*** ADDENDUM TO NOTICE OF DECISION ***

Case Number: RNA-DRB-20-01
Activity Number: T20SA00145
Review Type: Rio Nuevo Area (RNA)
Project Name: Farhang & Medcoff
Location: 100 South Church Avenue, Tax Parcel # 117-20-016H

This is an addendum to the approval notice issued on June 1, 2020, for the administrative professional offices at 100 South Church Avenue. The site is currently zoned OCR-2 office, commercial, and residential, and is located within the Rio Nuevo Area (RNA) overlay zone. The structure is not listed as, or eligible to be historic and is not on a designated or pending National Register.

NORTH ELEVATION | SCALE: 1/8" = 1'-0"

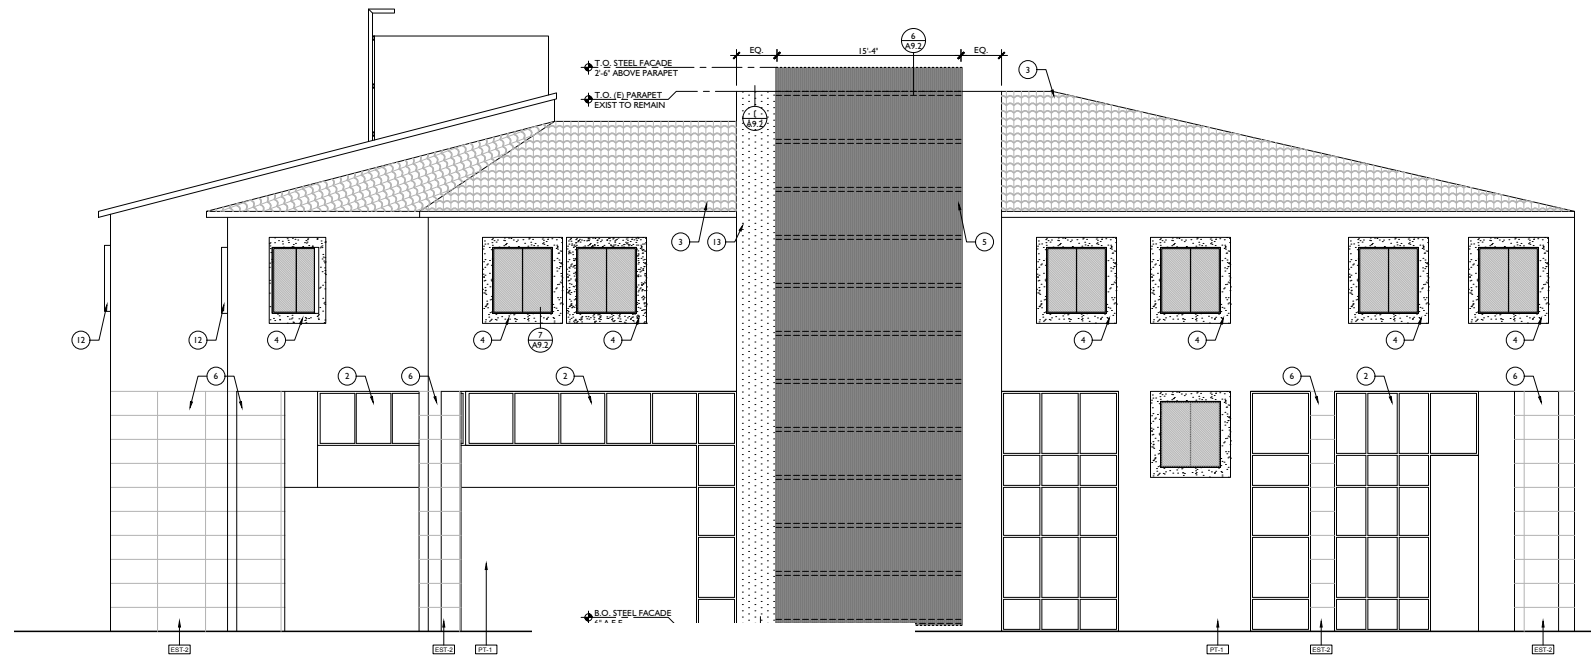
- 1) Maintain the previous land use on the property as professional and administrative offices. The original space on the ground floor that was planned for retail it is now planned for a conference room and storage for occupants, since adjacent property owner did not agree with the ADA access ramp to the entrance of the new retail space, making it now unfeasible;
- 2) Remove storefront entrance, ground floor windows, and accessible ramp and handrail on the south elevation. Main office entrance will remain;
- 3) Remove two windows on the ground floor of the east elevation;
- 4) Remove perforated metal panel at windows on ground floor east elevation; and
- 5) Steel façade to terminate even with the top of the parapet on the north and east elevations.

REVISED

4. REMOVE STUCCO POP OUT AND PROVIDE NEW STUCCO FINISH FLUSH WITH ADJACENT WALL. MATCH ADJACENT TEXTURE AND FINISH. PAINT PER FINISH SCHEDULE.
 5. SEALED STEEL TUBE FACADE. REF. NOTED DETAIL AND FINISH SCHEDULE. TUBE STEEL SUPPORTS BEHIND AT 4'-0" O.C. MAX. COORDINATE WITH EXISTING OPENINGS AS REQUIRED. REF. DTL. 11(A)9.2.

EAST ELEVATION | SCALE: 1/8" = 1'-0"

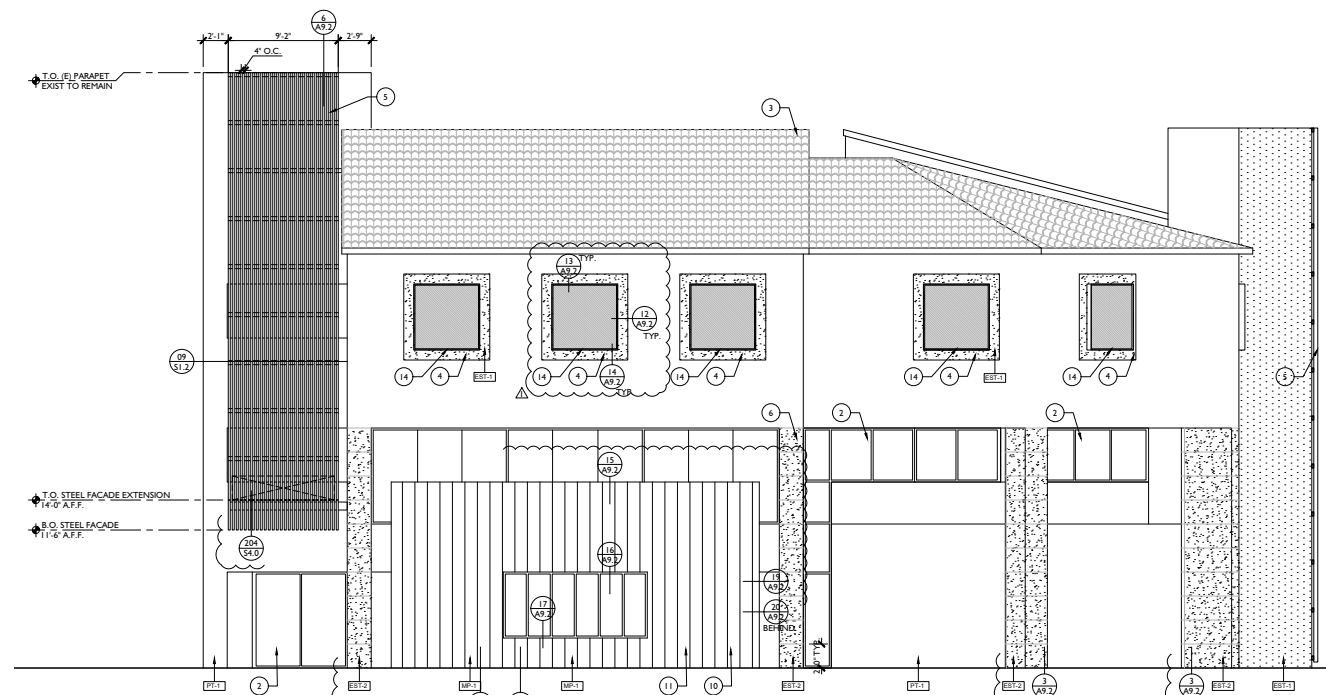
REVISED
